Exhibition of the Inland Rail North Star to NSW/Queensland Border Environmental Impact Statement

Inland Rail North Star to NSW/Queensland Border – Environmental Impact Statement

BCS's detailed comments

21 Plot names have been duplicated but data is different

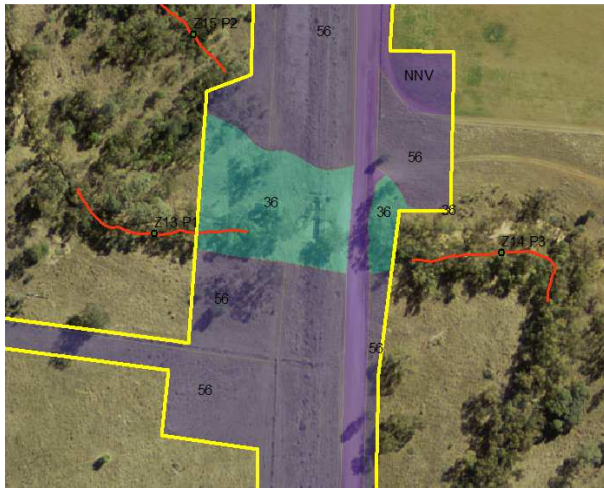
As per the example above there are some instances where the same plot name has been used but the data is different and in most instances only one of the two have been entered into the BAM-C. Additional examples where this has occurred are Plot IDs CB244LS1, CB244MS1, CB244MS2 and CB56LS3. In addition to the comments above an explanation is required to clarify why multiple sets of data exist for the same plot ID. BCS has reviewed the spatial data provided for plot locations and it is not always clear where the additional plots with the same Plot ID are located.

Example 1: Plots Z13 P1 and Z14 P3

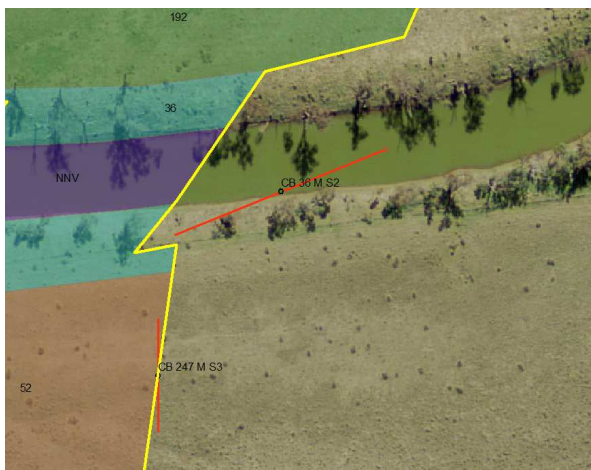
There are some plots where the transect does not follow a straight line. As per section 5.3.4.4 of the BAM, plots/transects must be established to provide a representative assessment of the vegetation integrity of the vegetation zone, accounting for the level of variation in the broad condition state of the vegetation zone. In the examples below the transect does not follow a straight line but instead appears to follow the denser woody vegetation present on site. This is not an acceptable approach to establishing a vegetation integrity survey plot.

Example 2: Plot Z14 P1

Example 1: Plot CB36MS2

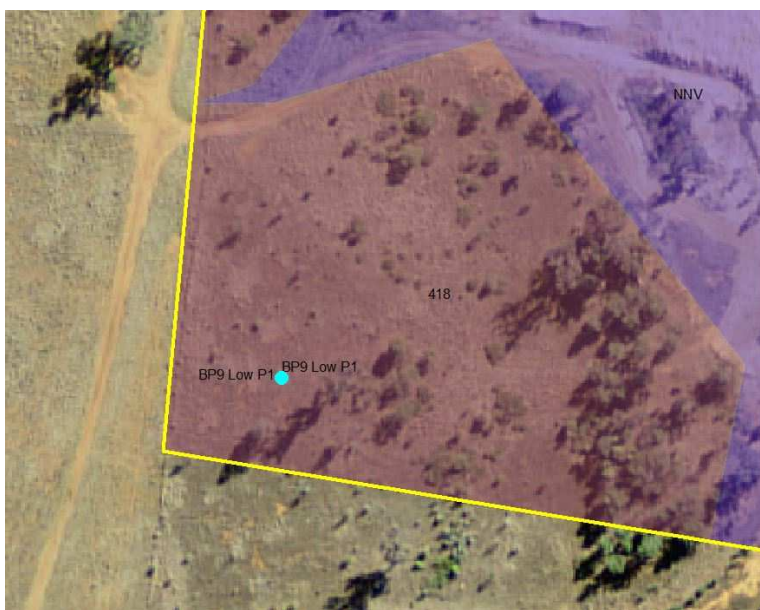
There are some plots that have not been appropriately placed to provide a representative assessment of the vegetation integrity of the vegetation zone. As per section 5.3.4.6 of the BAM plots should not be located in or near ecotones, vehicle tracks and their edges, or other disturbed areas that are readily distinguishable from the broad condition state of the vegetation zone. Examples are provided below where transects appear to cross into rivers and across roads.

Example 2: Plot NB35LS1

- 22.1 The location of all plots should be reviewed to ensure that they conform to BAM. Where relevant, justification should be included in the BDAR to explain the selection of transect locations.

Example 1: Plot ID Z17P1

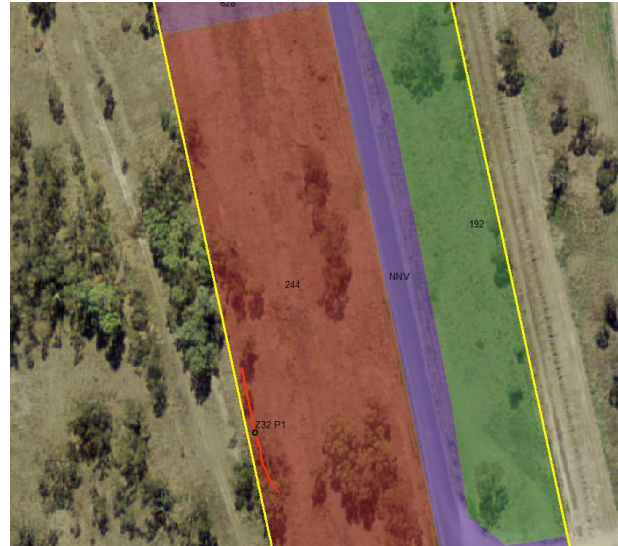
All data must be reviewed, and the mapping must accurately represent the vegetation on site.

Example 2: Plot ID Z32P1

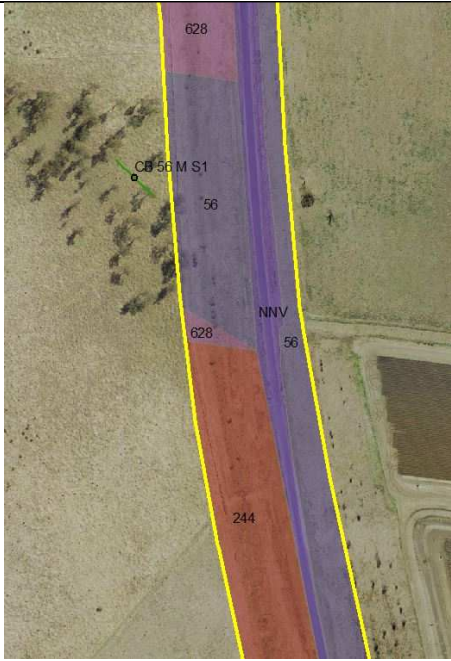
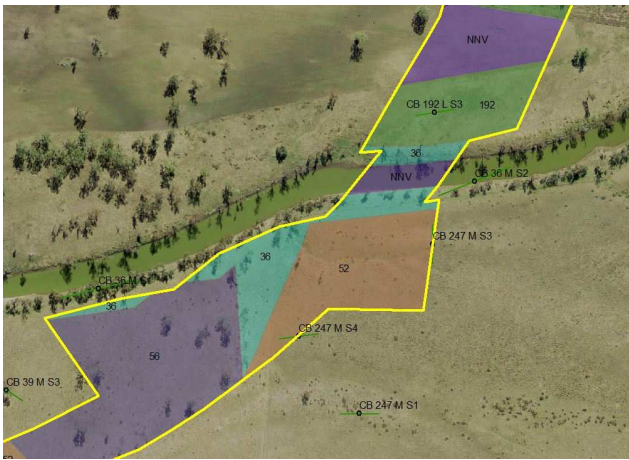
Example 2 - Plot ID Z32P1 has been identified as PCT628 and entered in the BAM-C for vegetation zone 628_CB_Medium, however the PCT mapping shows that the plot is located in an area mapped as PCT 244 Medium.
